## Proposal for Supplement 2 to the 03 series of amendments to Regulation No. 80 (Seats of large passenger vehicles and of these vehicles with regard to the strength of the seats and their anchorages)

The text reproduced below was prepared by the expert from Germany. It clarifies requirements regarding the safety device to be installed at side-facing seats. The modifications to the current text of UN Regulation No. 80 are marked in bold for new or strikethrough for deleted characters.

1. Arrangement in the approval mark for a seat

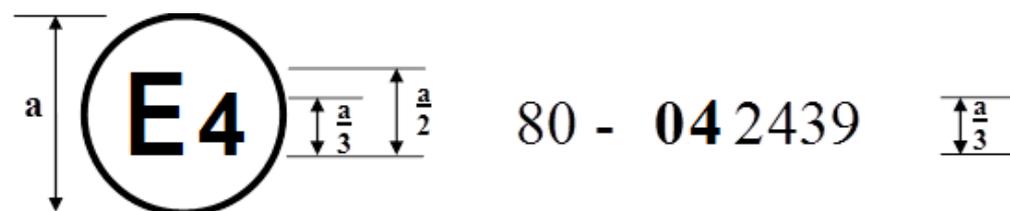
The above approval mark affixed to a seat shows that the seat type concerned has, with regard to the strength of the seats, the test being carried out in accordance with paragraph 2 of Annex 4, been approved in the Netherlands (E4) under number 042439. The approval number indicates that the approval was granted in accordance with the requirements of Regulation No. 80 as amended by the 04 series of amendments.

2. Arrangement in the approval mark for a vehicle type

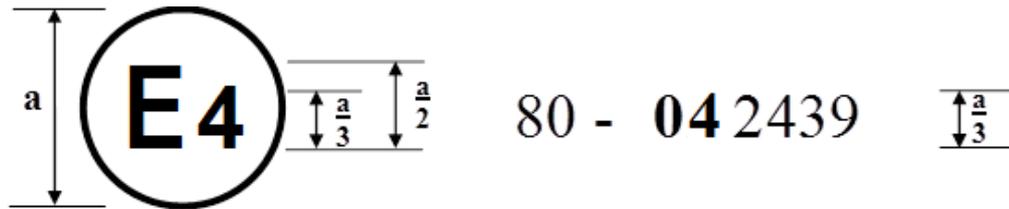
The above approval mark, affixed to a vehicle, shows that this type of vehicle has been approved in the Netherlands (E4) under number 042439 with regard to the strength of the anchorages on the vehicle. The approval number indicates that the approval was granted in accordance with the requirements of Regulation No. 80 as amended by the 04 series of amendments.
